Form C-103  
 Revised July 18, 2013

OXY USA Inc. - Proposed  
George Pagan 26 State #1  
API No. 30-015-30316  
EVAN DOHERTY, 5/4/22

GEORGE PAGAN 26 STATE #1

PROPOSED PLUGGING PLAN

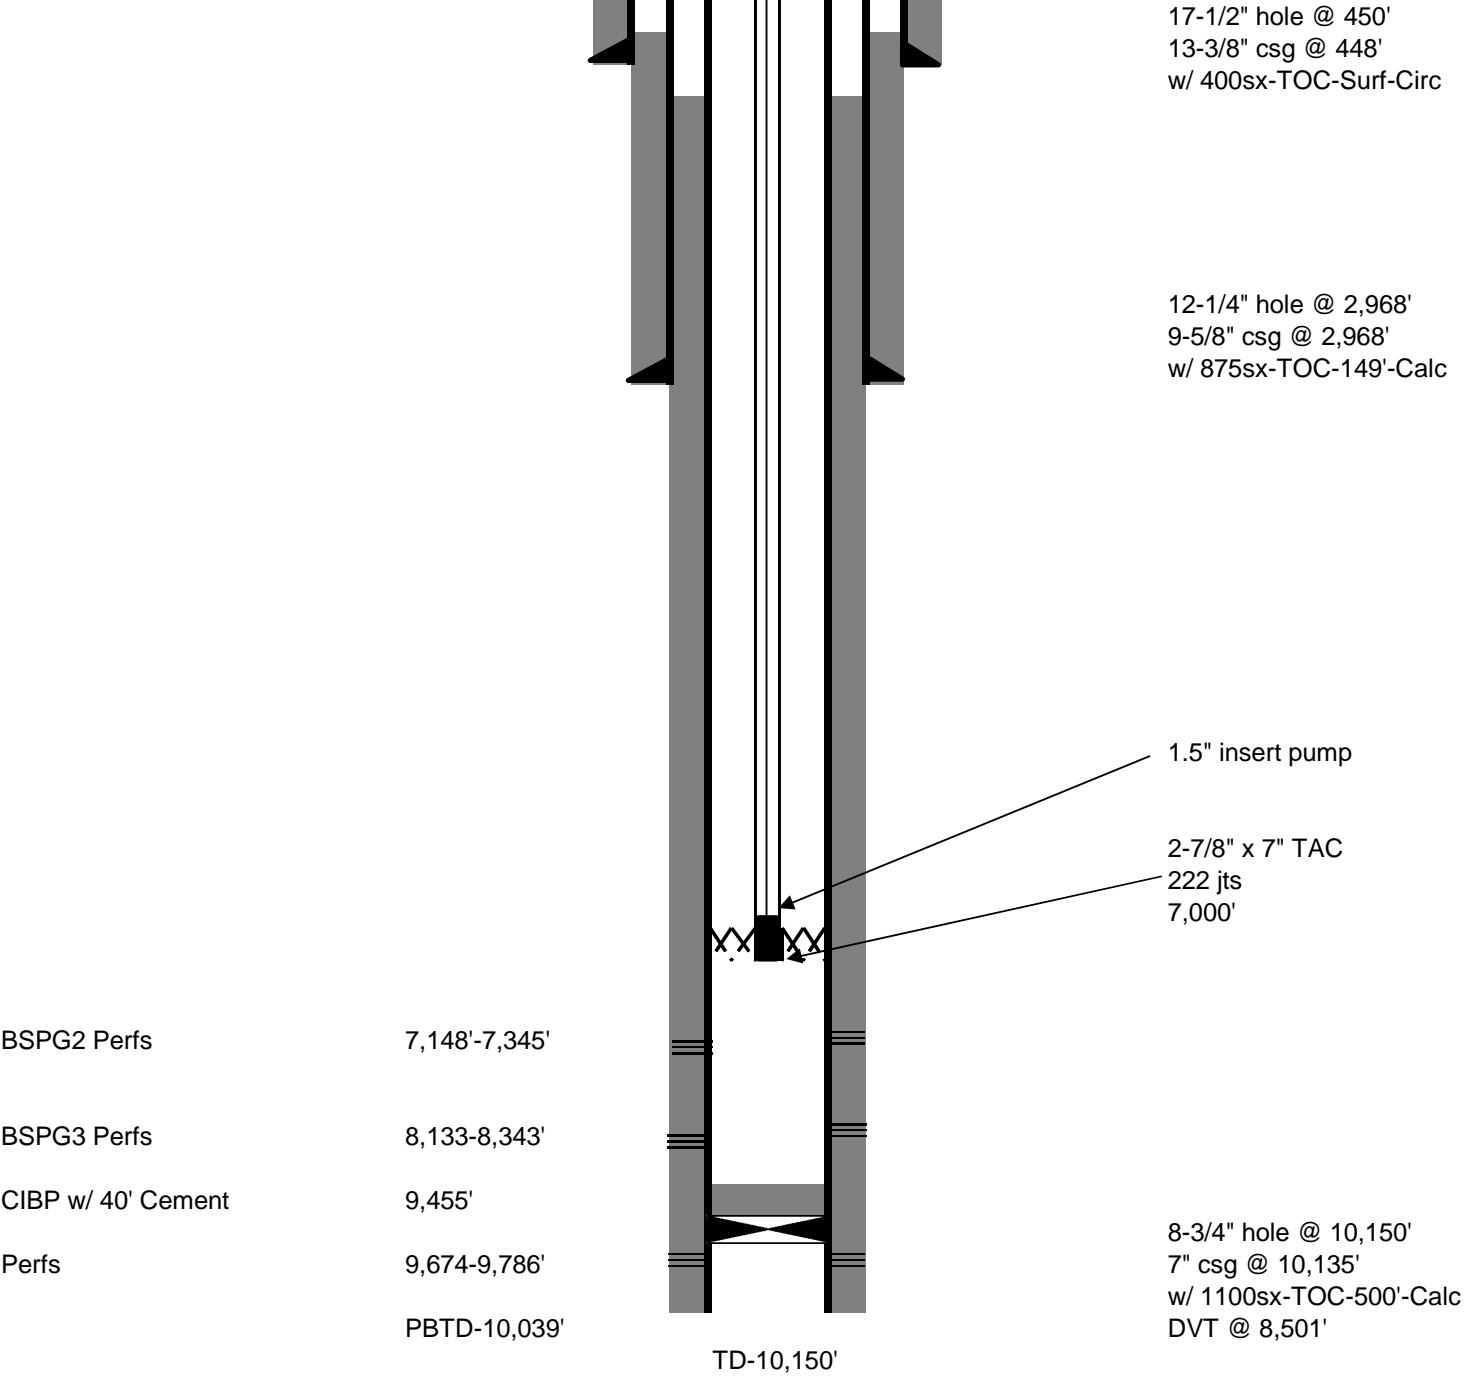
SEE CHANGES TO PROCEDURE

Perf @ 500'

Yates Plug 25 sx Perf @ 848'

Perf @ 3018'  
Intermediate Shoe Plug 25 sx

Perf @ 3770'  
Bone Spring Plug 25 sx

Perf @ 6360'  
Bone Spring 1 Balance Plug 25 sx

DB 6 sx cmt  
CIBP w/ ~~40~~ sx Cement  
BSPG2 Perfs

Run CBL to surface.
